TO: HONORABLE COMMISSION MEMBERS
FROM: Marcia Strange, Director of Community Development
DATE: April 8, 2026
SUBJECT: SITE PLAN REVIEW PSP26-0002 - 802 W MICHIGAN AVE - ROYAL SWINE

Royal Swine BBQ

**ROYAL SWINE BARBECUE
 SITE EXPANSION
 802 W MICHIGAN AVE, MARSHALL, MI 49068
 LAYOUT PLAN**

SHEET TITLE: **SITE LIGHTING PLAN**

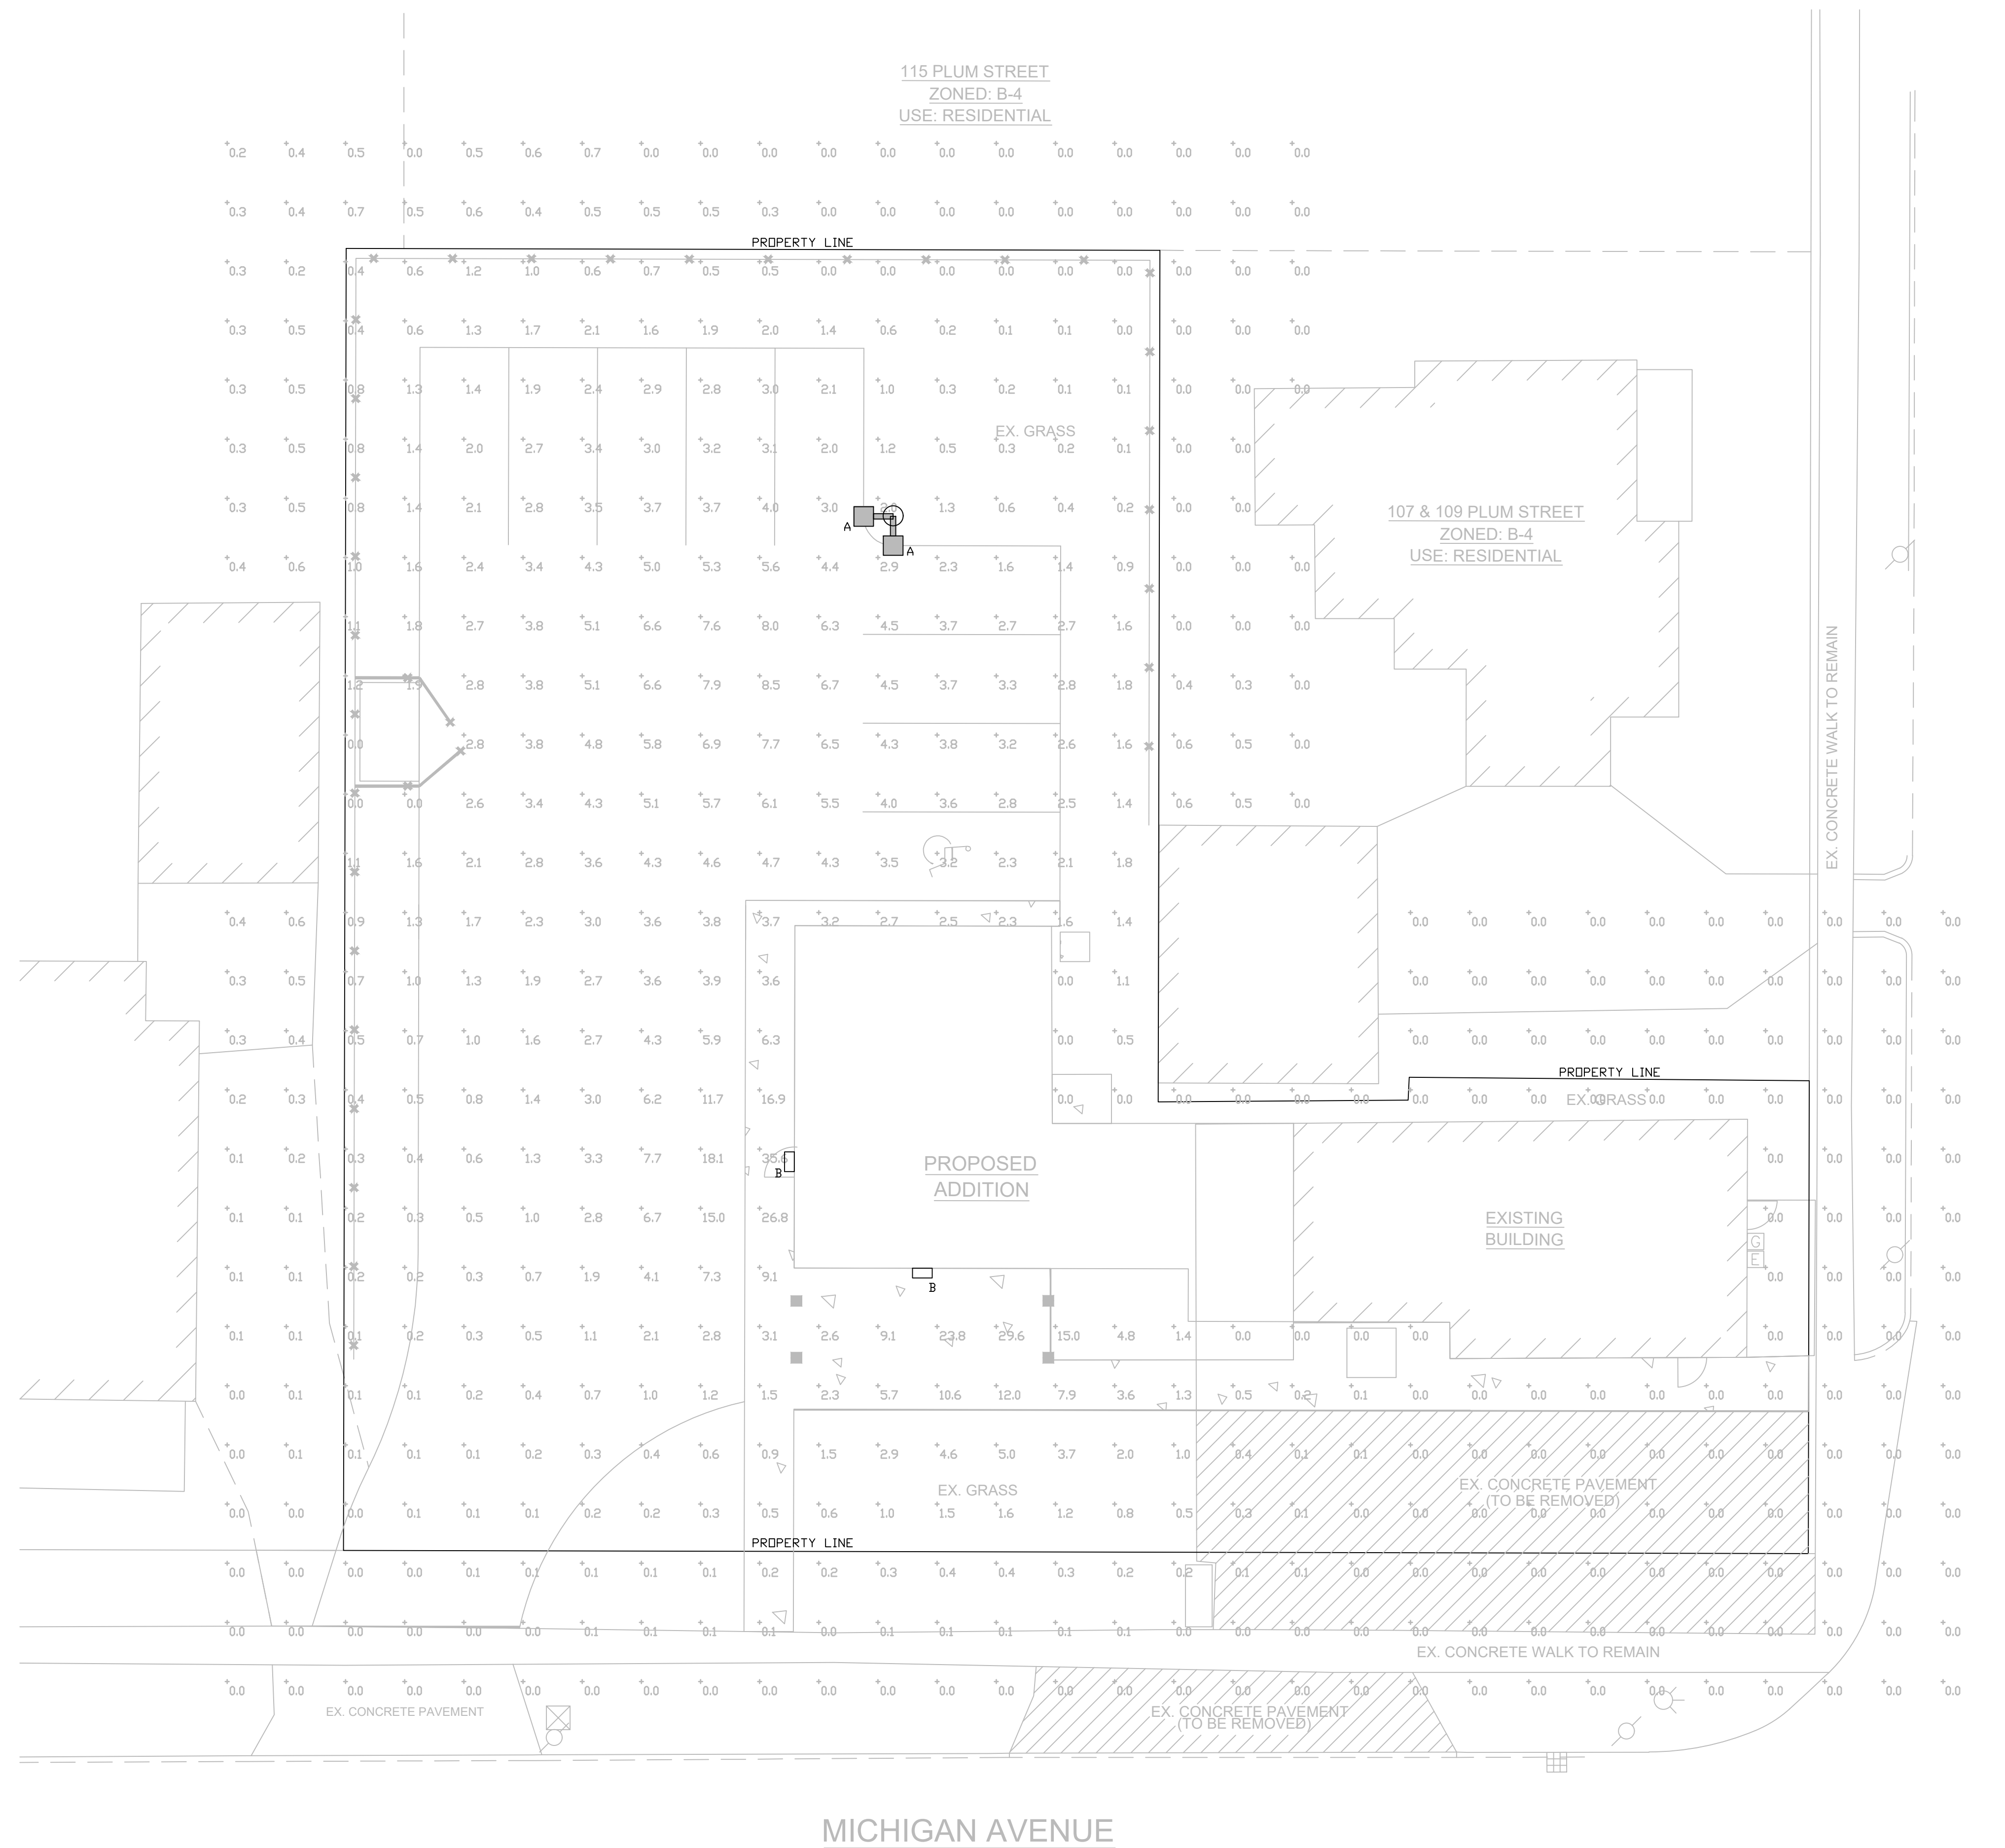
The required photometric plan was included with the submitted plans showing that the proposed development meets the ordinance standard of no more than 1 foot candle at a residential property line.

As mentioned above, the site meets the lighting requirements for downward lighting and light trespass. There is some concern about lighting at the exit door in the 'elbow' on the north side of the building. On-building lighting may need to be considered in this location for safe exit.

1. The addition of egress lighting at the north exit door.
2. Adjust the access to the adjacent parcel to be outside of the right-of-way and provide a shared access agreement for that drive.
